From: Katherine Williams
Sent: 03 December 2025 11:03:23 UTC+00:00
To: "'Sophie Hulton-Harrop'" <Sophie.Hulton-Harrop@mottmac.com>
Cc: "Tim Butcher" <Tim.Butcher@mottmac.com>
Subject: RE: DM/25/2283 and DM/25/2472 - Queen Victoria Hospital, Holtye Road, East Grinstead
Attachments: RE: DM/25/2283 and DM/25/2472 - Queen Victoria Hospital, Holtye Road, East Grinstead

From: Katherine Williams <Katherine.Williams@midsussex.gov.uk>
Sent: 23 October 2025 17:18
To: Sophie Hulton-Harrop <Sophie.Hulton-Harrop@mottmac.com>
Subject: DM/25/2283 and DM/25/2472 - Queen Victoria Hospital, Holtye Road, East Grinstead

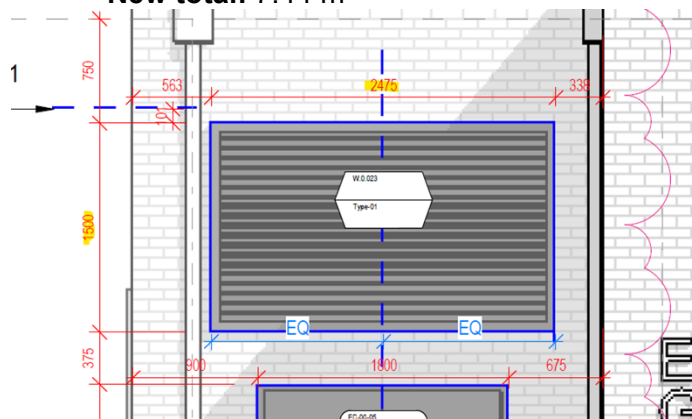
Regarding the updated louver design, please see more detail below.

The areas previously considered for the louvers were:

- **East side (square opening):** 3.44 m²
- **West side (rectangular opening):** 5.40 m²
- Total:** 8.84 m²

Due to clashes with columns and MEP minimum opening requirements, we are now proposing similar-sized openings for both locations:

- **Each opening: 3.72 m²**
New total: 7.44 m²

Please can you confirm that this change would constitute a Non-material Amendment and therefore a S96a application can be submitted?

- The new updated landscape plan is missing the key for the *Balustrade with Handrail Metal railing installed along the access path, including ramp and stair areas. Powder-coated finish (PPC) in RAL 1019*. Can this be clearly annotated.
- Regarding **Louver design** - *changed due to clashes with the structural grid, identified at detailed design stage. The dimensions of the louvers have changed slightly to accommodate the position of the structural columns and other building fabric elements*. Can I ask to describe 'slightly' in some numbers so I can get a better understanding of the scale of impact of this change.

With regards to the changes to the entrance ramp and louvers these amendments would be non-material and a S96a can be submitted. This will need to be submitted and approved before the conditions can be discharged to ensure there is no discrepancy.
